## General Service Bulletin

# IntelliPak™1 & IntelliPak™2 Condenser Fan Motor Failures

**RT-SVB194B-EN**

The purpose of this service bulletin is to advise the field of IPak™1 & 2 Condenser Fan Motor Failures.

Figure 2:

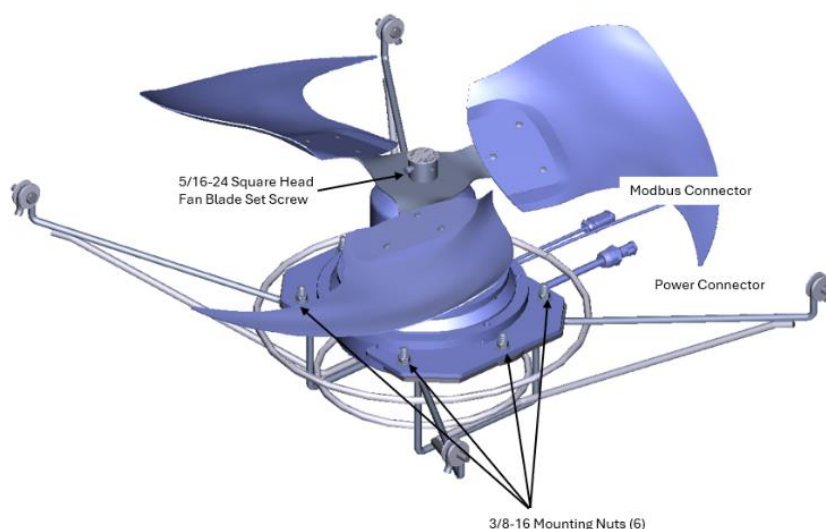
**Section 1: Replacing EBM Condenser Fan Motor & Fan Blades (Figure 2) to be done at site:** Only impacts units with EBM Condenser Fan motors which were manufactured with S/N 2406xxxxx (week 6 of 2024) or prior. DOES NOT IMPACT UNITS WITH REGAL MOTORS.

- 1.1. Update Firmware on Symbio 800 Controller: [Updating-Firmware-on-a-Symbio-800-Controller.pdf \(trane.com\)](#)
- 1.2. **If the unit has been installed and is running**, replace Condenser fan motors & fans. **If unit has not been installed or has no run time**, replace Condenser fan motors only. *Save replacement part packaging to return removed motors to Trane Supply in it.*

- 1.3. Power unit down
- 1.4. Remove condenser fan grill and set it to the side.
- 1.5. Loosen condenser fan set screw from motor's shaft.
- 1.6. Remove condenser fan blade.

- 1.7. Disconnect Power and Modbus harnesses.
- 1.8. Remove 6 nuts that secure the motor and bracket and remove condenser fan motor assembly.
- 1.9. Install replacement condenser fan motor in its place and tightly secure all 6 nuts.

- 1.10. Reconnect Power and MODBUS wiring. **IMPORTANT:** If you are replacing multiple condenser fan motors, you can physically replace all motors at the same time but only reconnect Power and MODBUS cables of one of the new condenser motors initially. *Connecting multiple new motors at the same time will affect motor addressing (see steps below).*
